Intelligent Multi-Agent Rainwater Management for Urban Flood Mitigation

CS3081 – Report 3: Proposed AI Solution & Architecture Diagram

2. Architecture Diagram

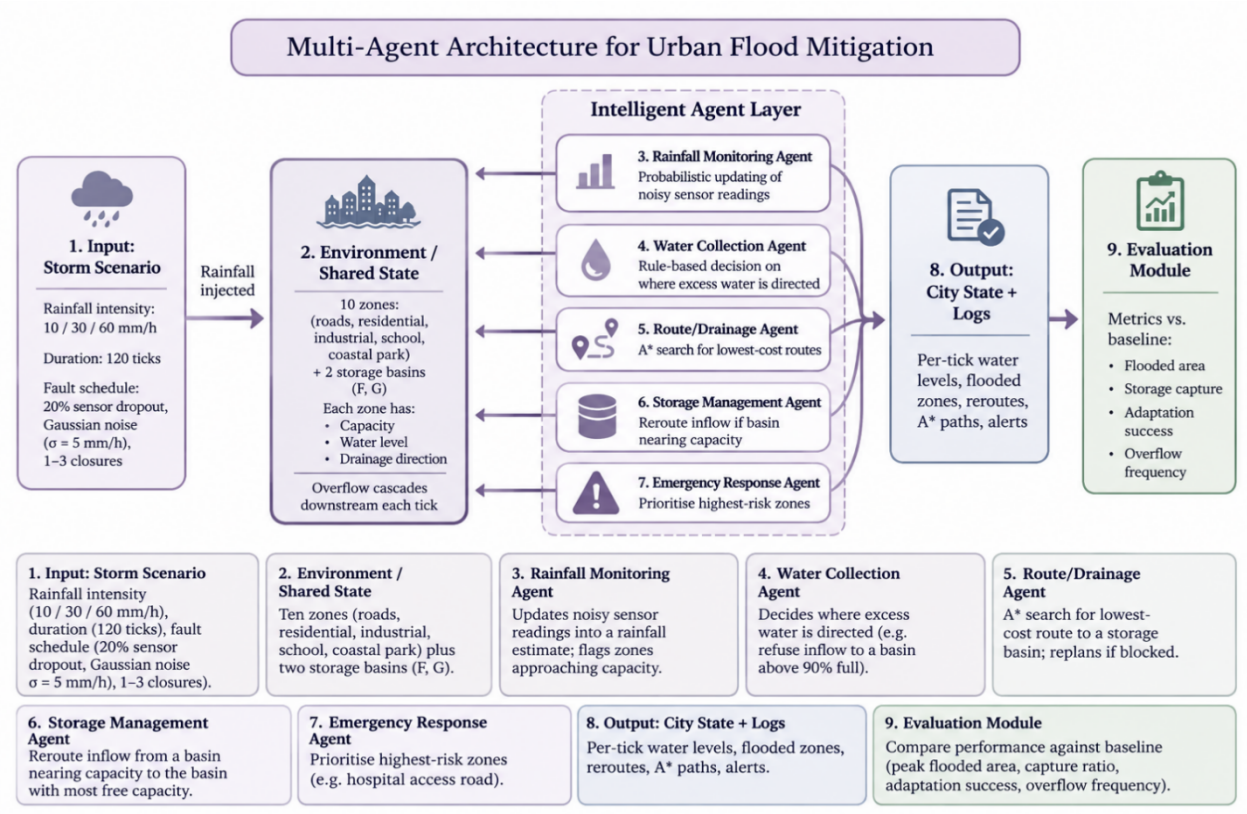
Architecture clarity and data flow **2.5 / 3**	**Strengths** The architecture diagram is coherent: input → shared environment → five-agent layer → output/logs → evaluation. The shared environment model as single source of truth is well-motivated and matches the blackboard coordination in [13]. The data flow from noisy sensors → probabilistic estimate → downstream agents is explicit. The mapping of each agent to a technique is clear in Report 3, Section 4. **Weaknesses** Unclear data flow between Rainfall Monitoring and the other agents. The diagram shows Rainfall Monitoring feeding the environment state, but it is not specified how the posterior rainfall estimate is consumed by Water Collection, Route/Drainage, or Storage Management. Does Water Collection use the posterior to decide admission? Does Route/Drainage use it to weight edges? If not, the "sensing without action" gap is only closed at the state level, not at the decision level. Emergency Response overlaps with Water Collection and Storage Management: all three are rule-based, and the boundary between "where excess water is directed" (Water Collection) and "which zones are prioritised" (Emergency Response) is fuzzy. Evaluation module is outside the agent loop — fine, but it should be explicit that it observes logs, not the live state.	Add one sentence per consumer agent stating exactly which fields of the shared state it reads (e.g., "Water Collection reads posterior_rainfall[zone] and basin_fill_ratio"). Define the Emergency Response agent's trigger condition precisely (e.g., "activates only when a zone exceeds 90% capacity and no admissible route exists").

2. Is the architecture logically connected and technically correct? Unnecessary modules or unclear flows?

Logically connected, yes. The shared environment as single source of truth is correct and matches the blackboard pattern in [13]. The input → state → agents → logs → evaluation flow is sound.

Two unclear flows and one overlap:

- **Rainfall Monitoring → downstream agents**: the posterior estimate is written to state, but it is not specified which agents read it or how it changes their decisions. If no agent consumes it, the "sensing without action" gap is not actually closed at the decision level.
- **Emergency Response vs. Water Collection/Storage Management**: all three are rule-based, and the boundary is fuzzy. Emergency Response should have a distinct trigger (e.g., "activated only when a critical zone is at risk and no admissible route exists") or be merged into Water Collection.
- **No unnecessary modules** — all five agents map to a stated gap. The evaluation module is correctly outside the loop.

1. Aligned Report 3 to Report 1's five-agent architecture: added the Water Collection and Emergency Response agents, which the earlier draft omitted, so the architecture report and the project description describe the same system.
